## **MCGOWIN PARK EAST OF SATCHEL PAIGE SUBDIVISION, RESUBDIVISION OF**

APPLICATION NUMBER 14 DATE June 4, 2015

APPLICANT McGowin Park East of Satchel Paige Subdivision, Resubdivision of  
REQUEST Subdivision

# DETAIL SITE PLAN

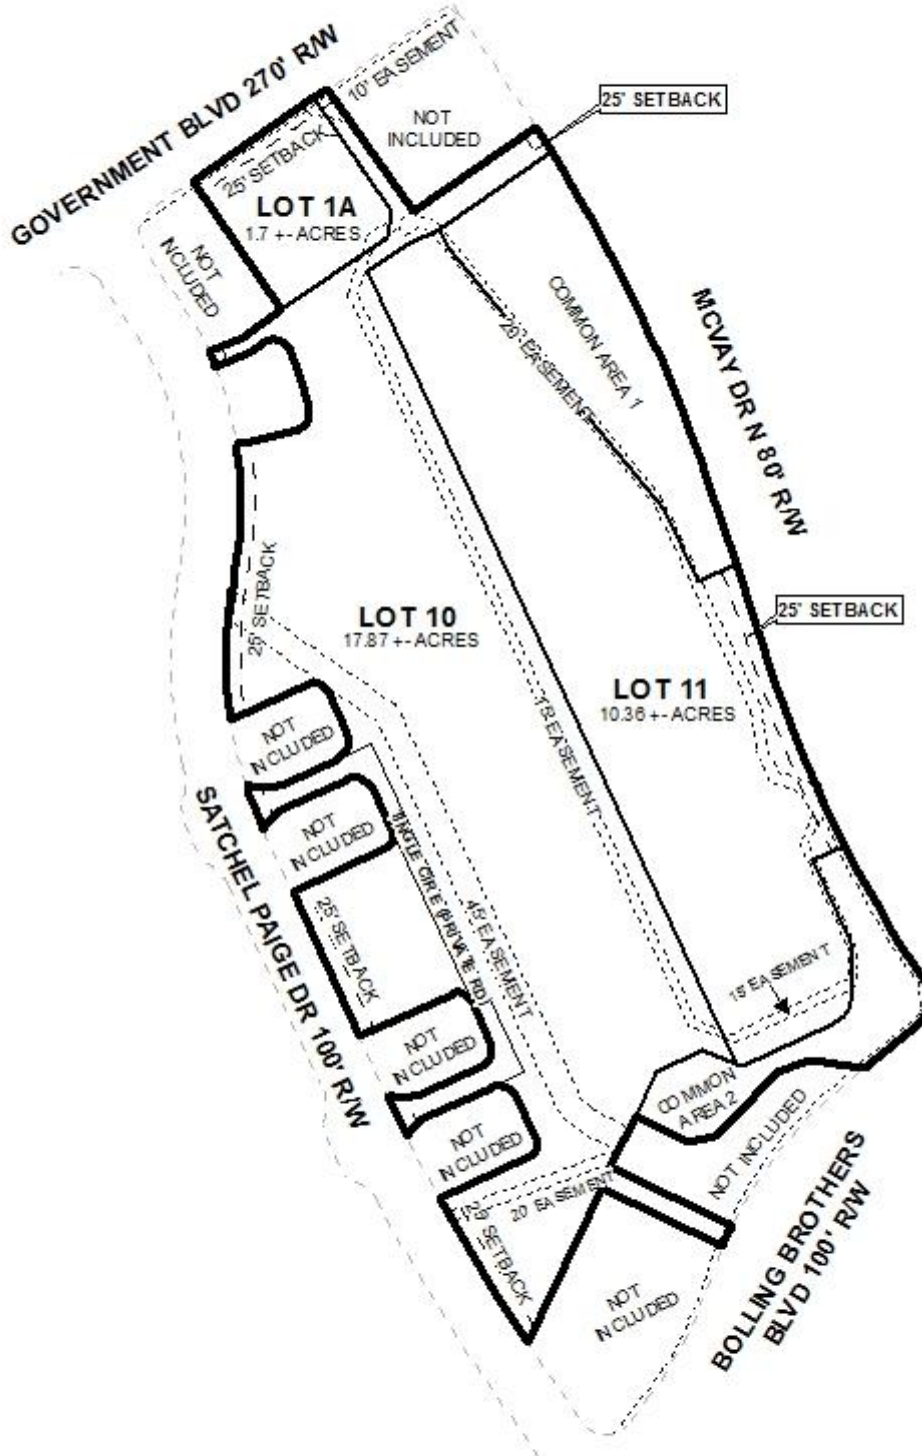
All lots will meet the minimum lot size requirements of Section V.D.2. of the Subdivision Regulations. The lot size information in square feet and acres should be retained on the final plat, if approved.

The 25-foot minimum building setback line, required in Section V.D.9., is shown the preliminary plat, and should be retained on the final plat, if approved.

Detention basin common areas are proposed for the subdivision. A note should be placed on the Final Plat, if approved, stating that maintenance of the detention basin common areas, and any other common areas, are the responsibility of the subdivision's property owners.

Multiple drainage and utility easements are depicted on the preliminary plat. All easements should be labeled on the final plat, and a note should be placed on the final plat stating that no permanent structures shall be placed in any easement.

- 1) Submission of seven (7) copies of the recorded plat for the McGowin Park Subdivision approved at the April 3, 2014 Planning Commission meeting;
- 2) Placement of a note on the final plat stating that the number, size, design and location of any new curb-cuts or modification of existing curb-cuts are subject to compliance with the approved PUD site plans, Traffic Engineering approval, ALDOT approval where required, and to conform with AASHTO standards.;

- 3) Retention of the 25-foot minimum building setback line for all lots with frontage on a public street, as required by Section V.D.9. of the Subdivision Regulations;

- 4) Labeling of all common areas and detention areas, and placement of a note on the final plat stating that maintenance of the detention basin/common areas, and any other common areas, are the responsibility of the subdivision's property owners;

- 5) Labeling of all drainage and utility easements on the site, and placement of a note on the final plat stating that buildings and other permanent habitable structures are not allowed in easements;

- 6) Retention of the labeling of each lot with its size in square feet and acres, as depicted on the preliminary plat
- 7) Compliance with Engineering comments (*The following comments should be addressed prior to submitting the FINAL PLAT for acceptance and signature by the City Engineer: A. Provide and label the monument set or found at each subdivision corner. B. Provide the Surveyor's, Owner's (notarized), Planning Commission, and Traffic Engineering signatures. C. Provide an updated Plat to Engineering Dept. for review prior to submittal for City Engineer's signature. D. Provide a copy of the Final Plat along with the original when submitting for City Engineer signature.*);
